Title: Advisory Committee on Reactor Safeguards
 Sodium Reactor Design-Center Subcommittee

NATRIUM REACTOR DESIGN-CENTERED SUBCOMMITTEE

TerraPower Topical Report "An Analysis 9

NRC Review of the TerraPower Topical 42

VHA: Tephra Fallout 1

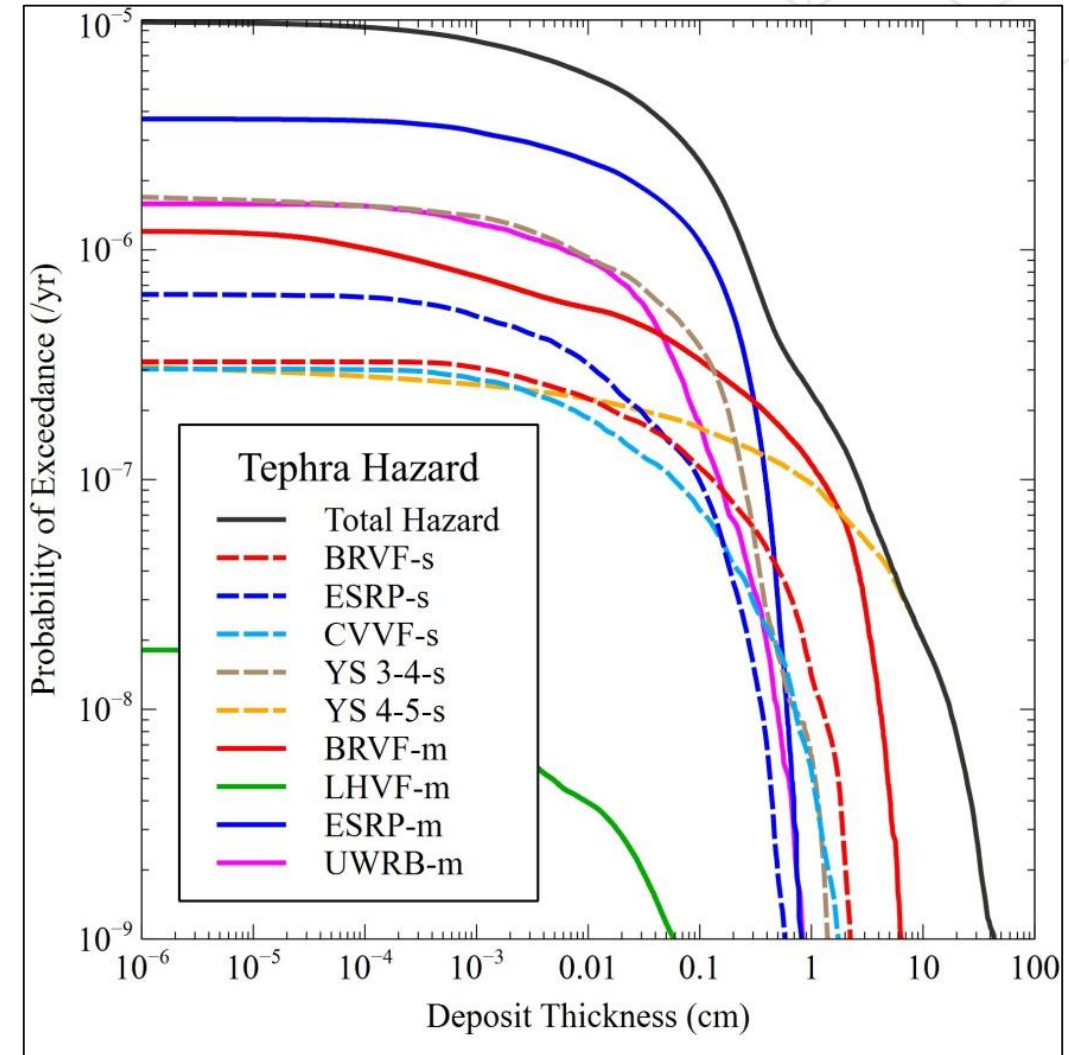
2 CHAIR ROBERTS: Yes, Britt, just to
3 clarify. The total hazard curve does not include
4 super volcano, right?

12 So for most of these volcanoes, the
13 average thickness is about 1 millimeter with a 10 to
14 the minus six probability of exceedance at the
15 proposed site. And more importantly, our 95th
16 percentile thickness which has, coincidentally, a 5
17 times 10 to the minus 7 probability of exceedance, is
18 about 17 centimeters. So that is one first part of
19 the risk assessment.

5 MR. HILL: It does not include a super
6 volcano. This is the first part. To jump to the
7 chase, we don't have enough information to
8 probabilistically characterize the super volcano
9 eruption, but we do have enough to gain some
10 statistical insights. I'll come to that in the next
11 slide.
